**Case File Number: PLN22006**

**October 26, 2022**

<b>Location:</b>	<b>1919 Webster Street</b>
<b>Assessor's Parcel Number(s):</b>	<b>008 063700808</b>
<b>Proposal:</b>	Major Conditional Use Permit for Large-Scale Development on a corner lot by demolishing an existing commercial building and surface parking lot in order to construct a 17-story, 269.8-foot-high office tower with a basement level parking garage. The project includes three Minor Variances for tower lot coverage, off-street loading, and bicycle parking.
<b>Applicant:</b>	1919 Webster Street Owner, LLC
<b>Contact Person/ Phone Number:</b>	Matt Weber, Ellis Partners/(415) 391-9800
<b>Owner:</b>	1919 Webster Street Owner, LLC
<b>Case File Number:</b>	PLN22006, PLN22006-ER01
<b>Planning Permits Required:</b>	Major Conditional Use Permit for Large-Scale Development; two Minor Conditional Use Permits for Administrative Commercial Activities at the ground floor and within 30 feet from any street-abutting property line; Minor Variances for tower lot coverage, off-street loading, and bicycle parking; Regular Design Review; and a Tentative Parcel Map to merge two lots into one lot (VTPM11233).

## CITY OF OAKLAND PLANNING COM

1/16" = 1' - 0" PRINTED ON 30X42 PAPER

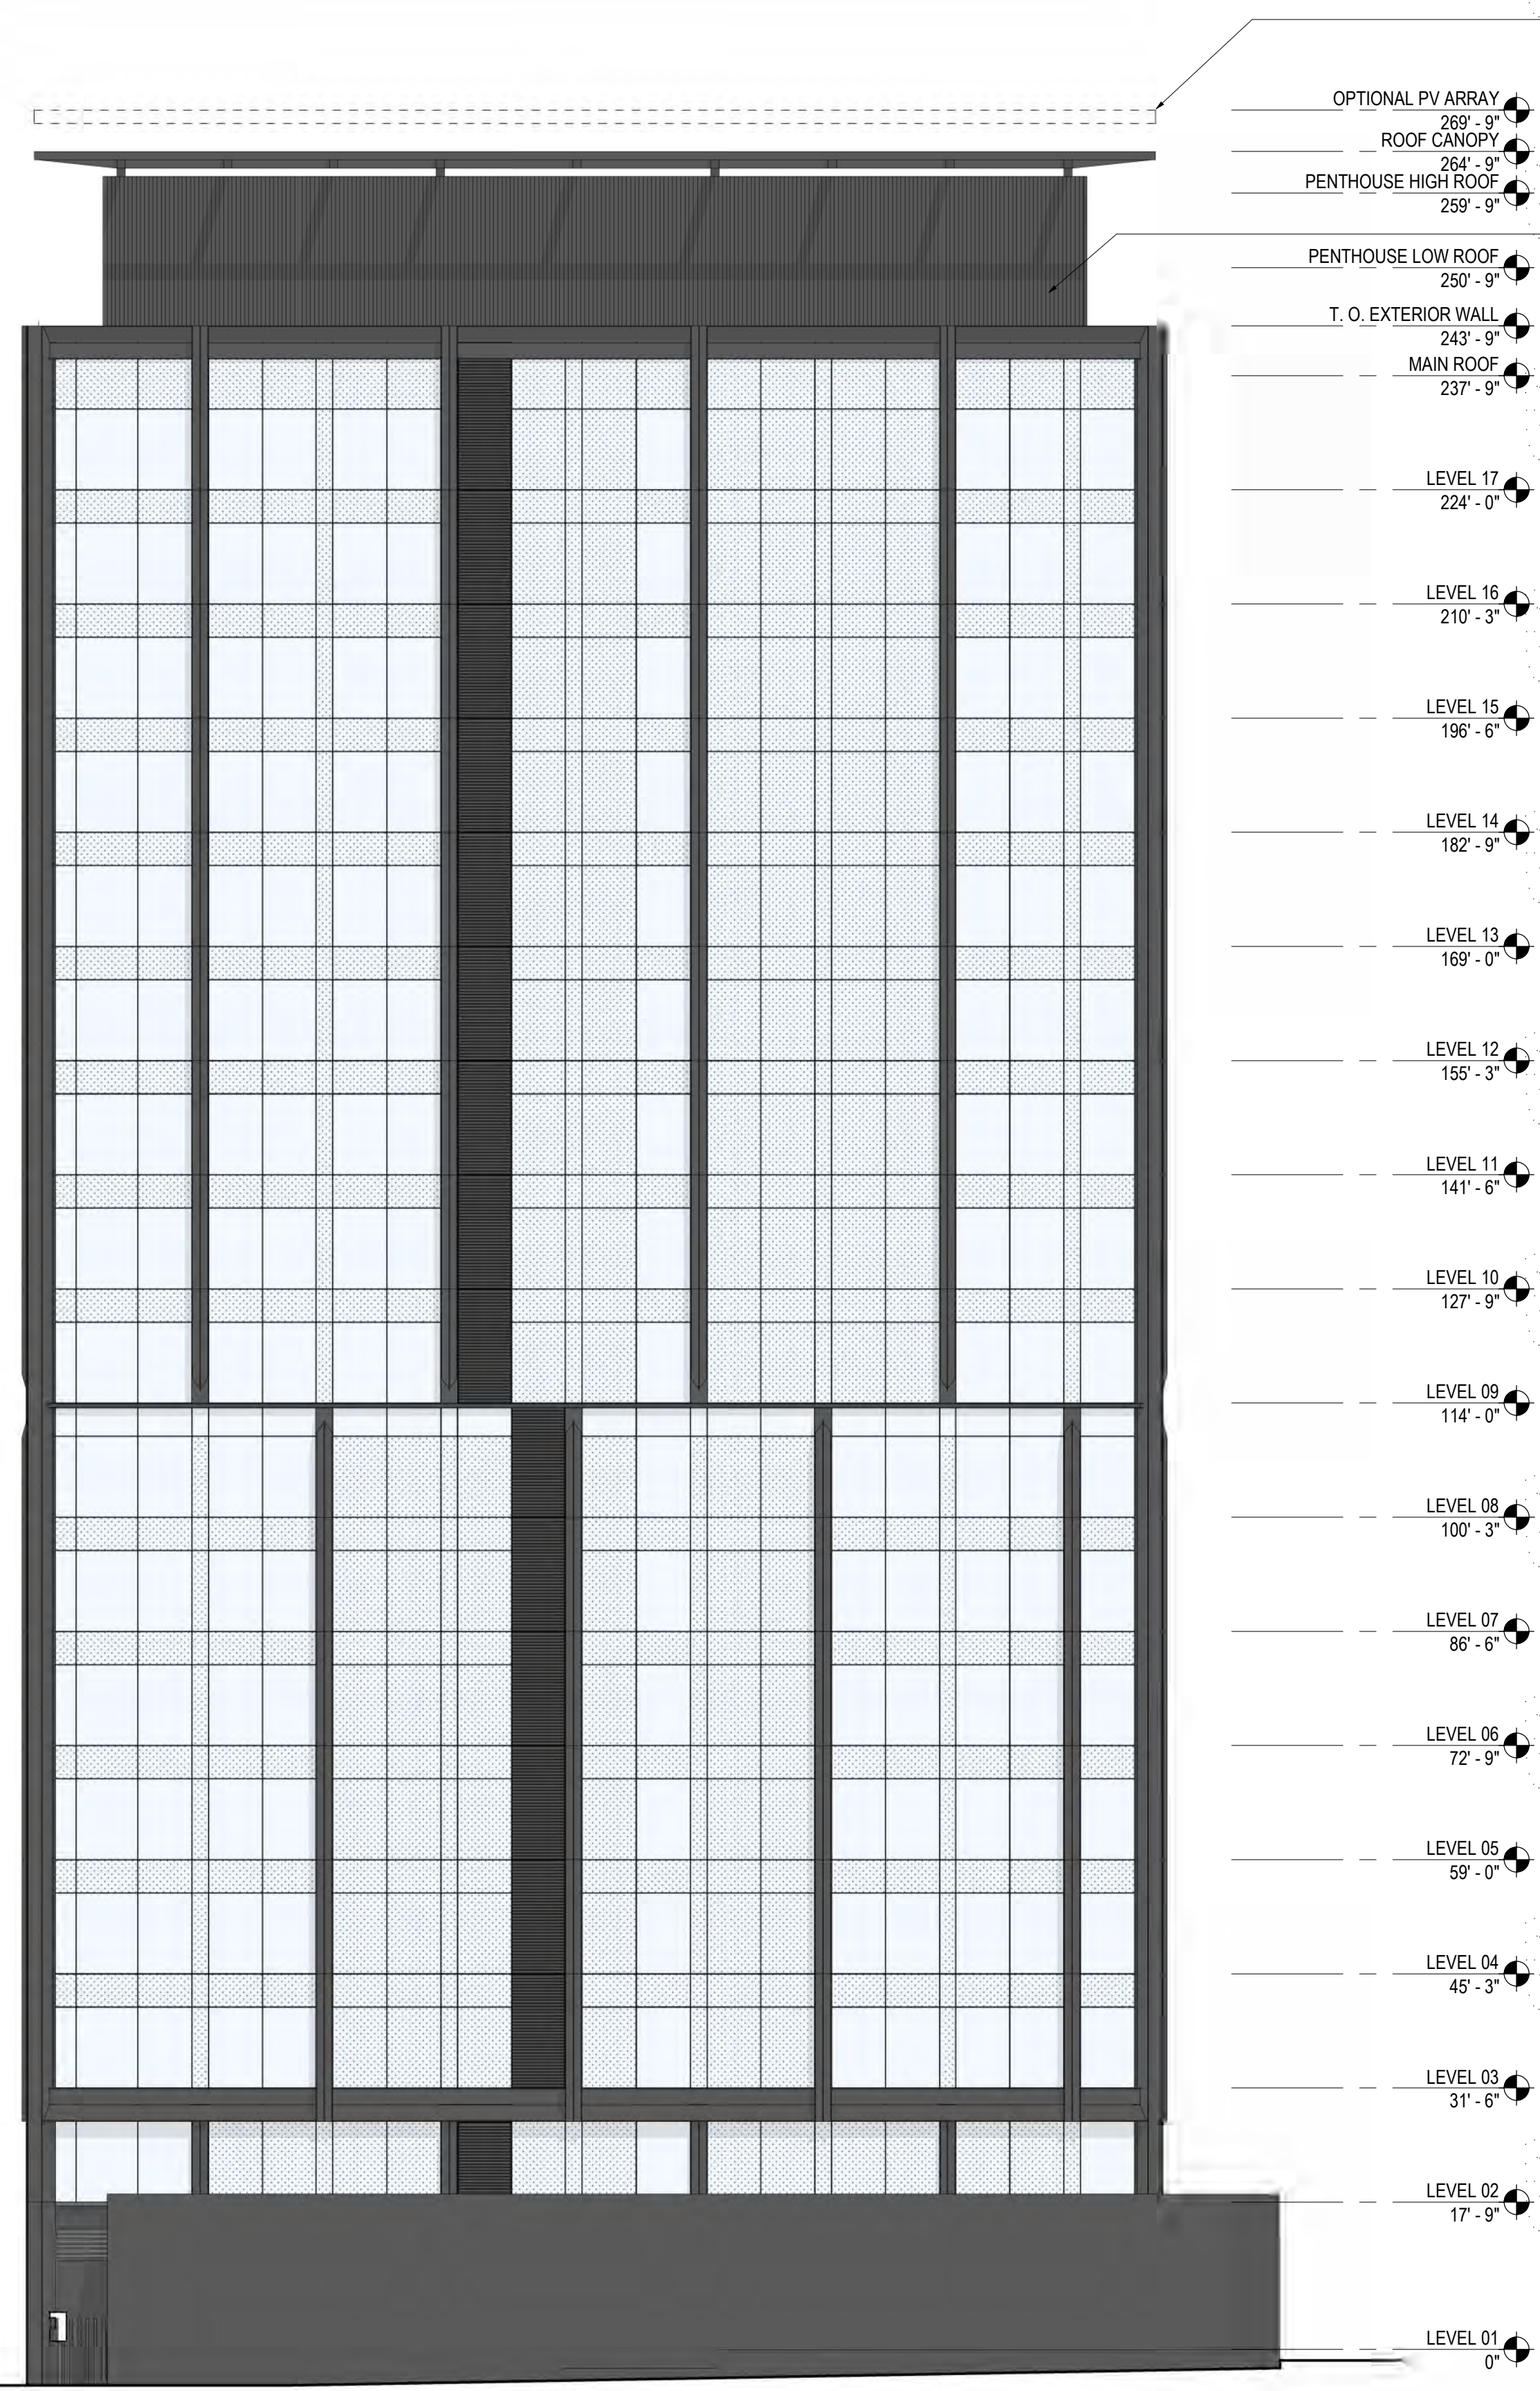
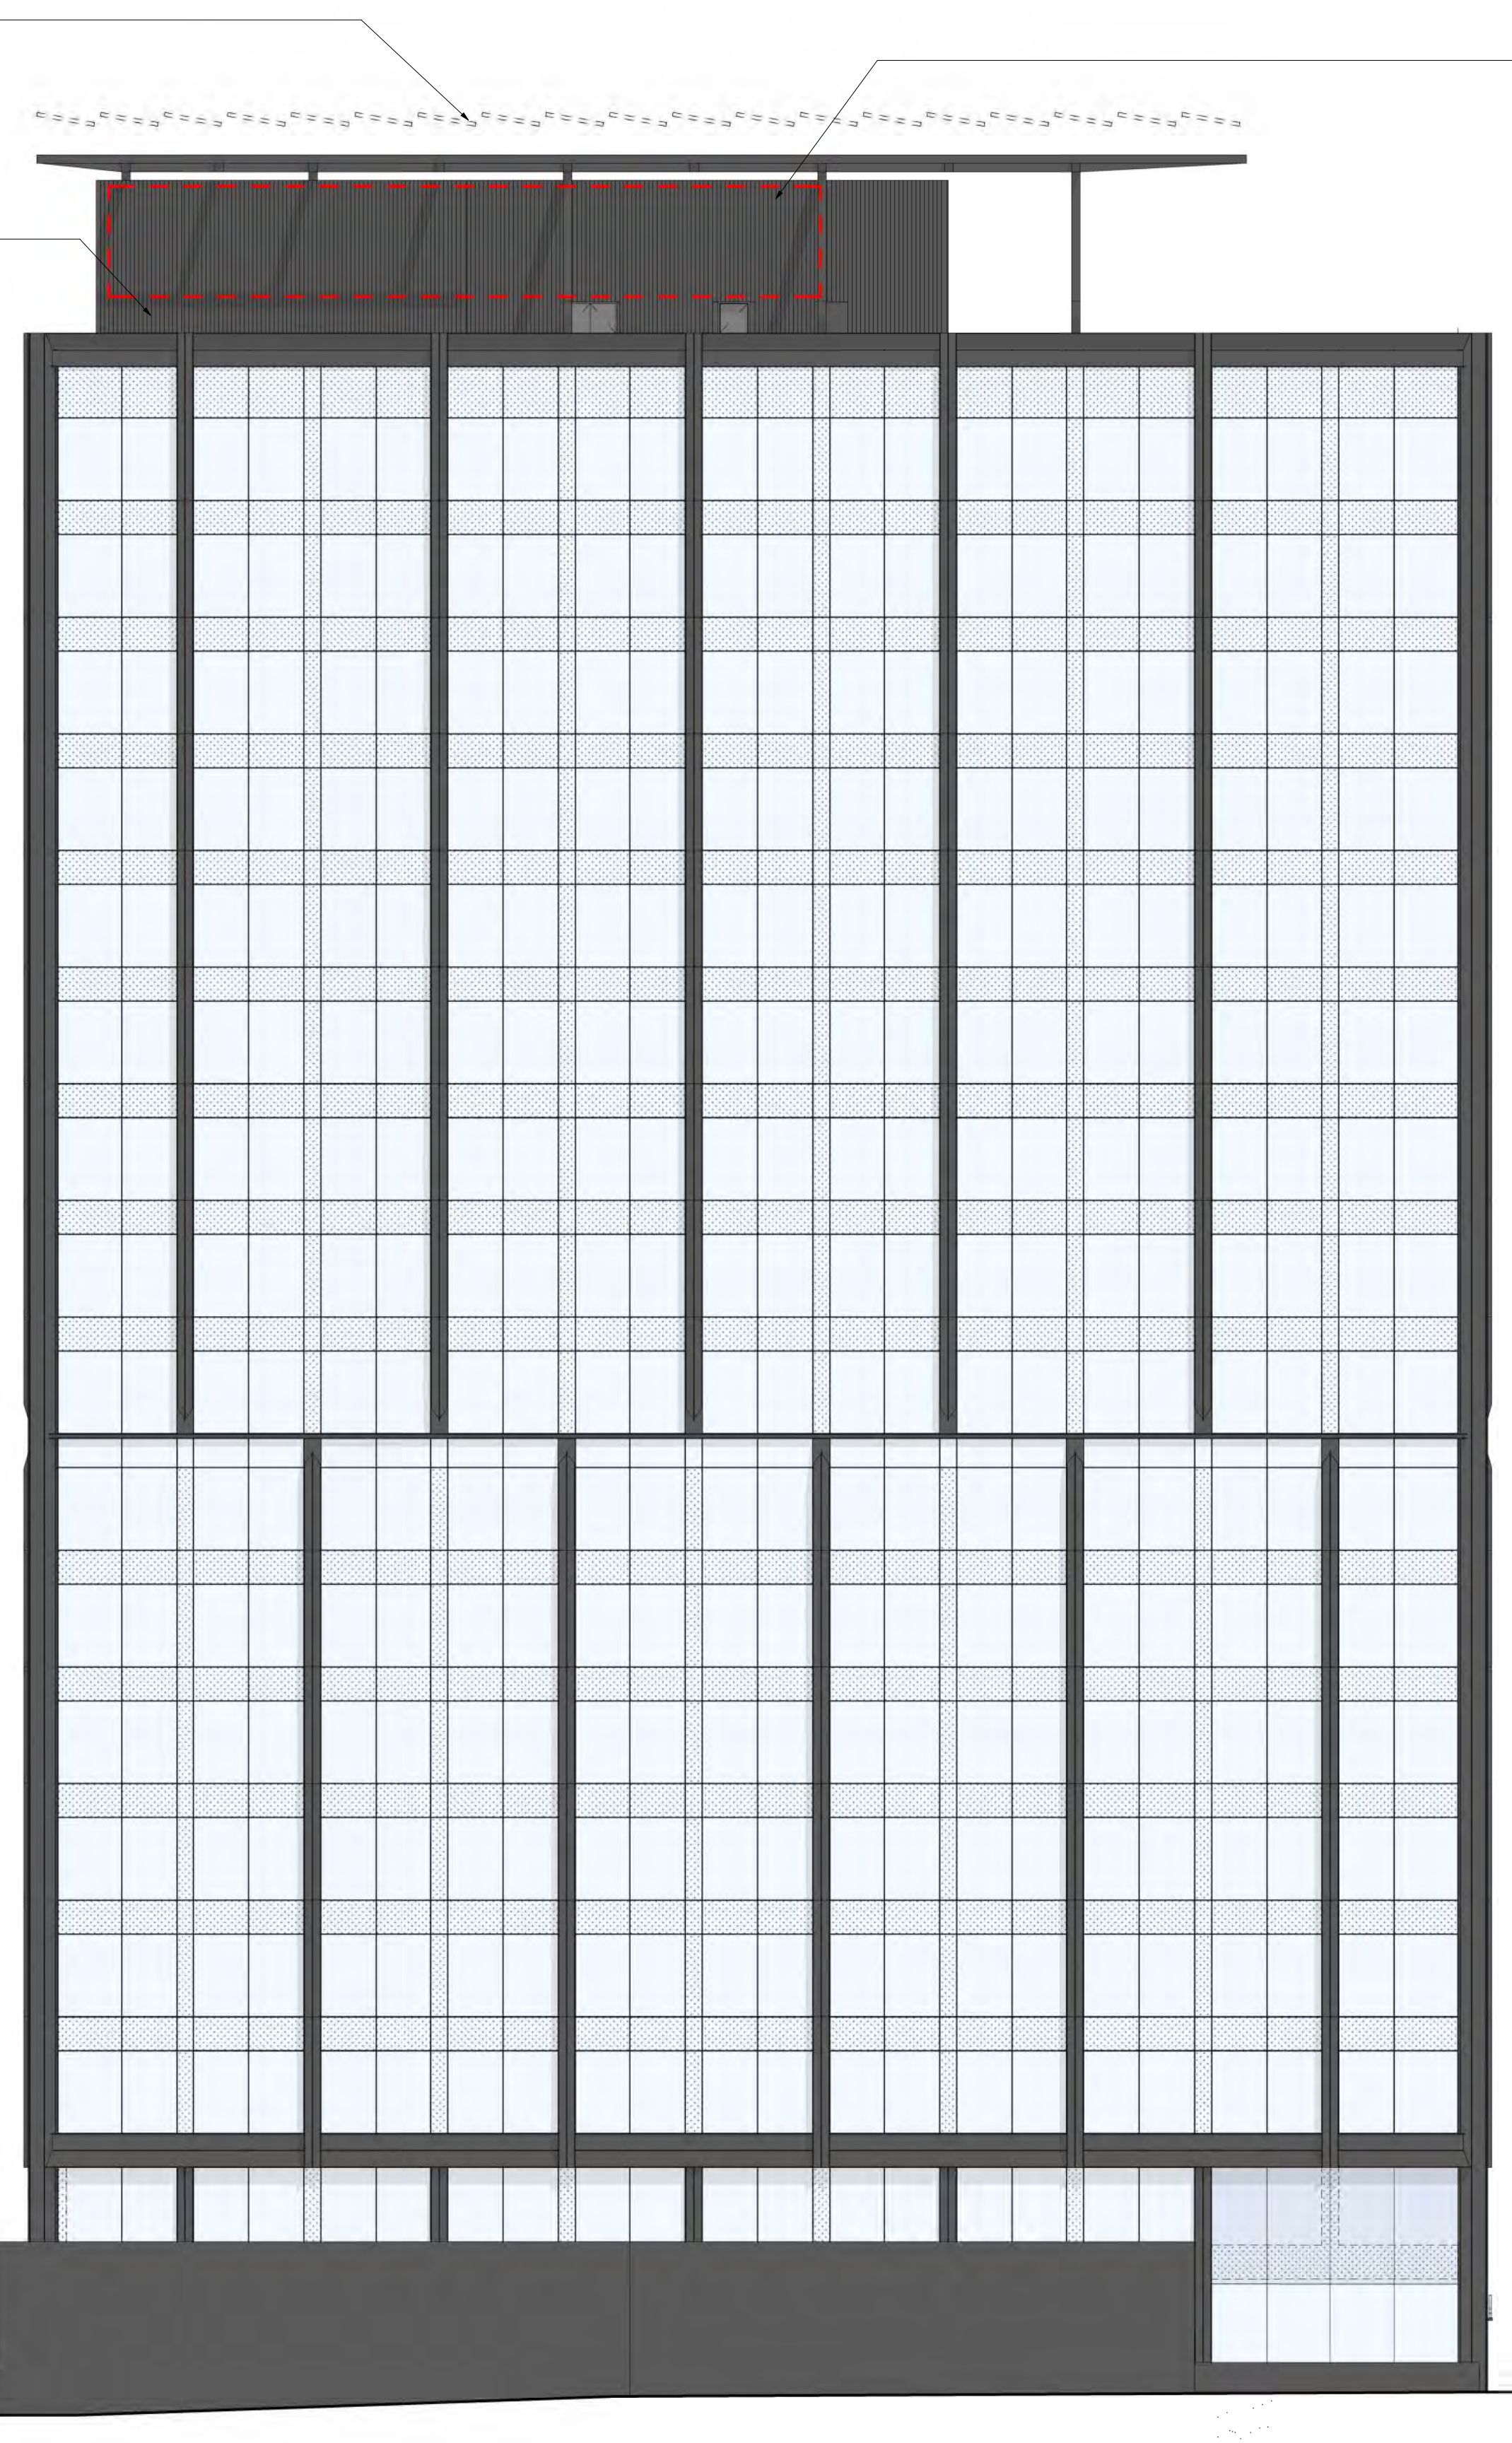
- **Entrance.** The renderings, material photos and floor plans show a short projection above the recessed lobby doors which are not clearly labeled in terms of the extent of the projection in the door area, change in materials, and additional detailing such as an awning or other features. Neither door exerts much prominence in comparison to the doors shown for the retail spaces on 19th Street.
  - *Does the DRC think the entrances should be enhanced additional detailing, more overhead projection and/or room for pedestrians to transition from the building interior to the streetscape?*
- **Ground Floor Treatment.** One color change, from brushed light gray metal to dark metal is the only exterior material listed for the ground floor design which is different

- from the tower materials. The retail space doors will open and encroach on the public right-of-way by about three and a half feet. Also, there only two street trees proposed for 19<sup>th</sup> Street and no street trees shown for Webster Street on the landscape site plans (Attachment A, page 35, Sheet L1.01.2). The design does not adequately show how the pedestrian experience would be enhanced.

- *Does the DRC think the proposed design should be revised to show how the design enhances the visual experience and is distinguished from the upper stories?*

- **Massing.** The box-like shape of the building exaggerates the mass and scale of the building. The lack of detail on the façade such as dimensions for projection or recesses, or lack of a distinct middle to the building creates a bulky and boxy building with a looming visual impact. There is little contrast, sculpting or articulation of the building from the base leading to the terminus which does not adequately differentiate between base, middle and top of the building. Also, as stated above, the applicant has revised the recessing and emphasis of the balconies' dimensions, but the focus of articulation and projection remains mostly on the building corner.

- *Does the DRC think the proposed design should be revised to refine the exterior and reduce the impression of a massive, boxy tower?*
  - **Building Terminus.** The roof features a penthouse structure storing mechanical and electrical equipment, the elevator run, and a partially visible canopy overhang. The applicant proposes two options for the roof top treatment and neither provides a distinct visual terminus.

- *Does the DRC think that by using architectural features such as curvilinear or stepped forms to soften the truncated tops of buildings, or by adding cornices or other architectural forms would help achieve a more distinct visual terminus?*
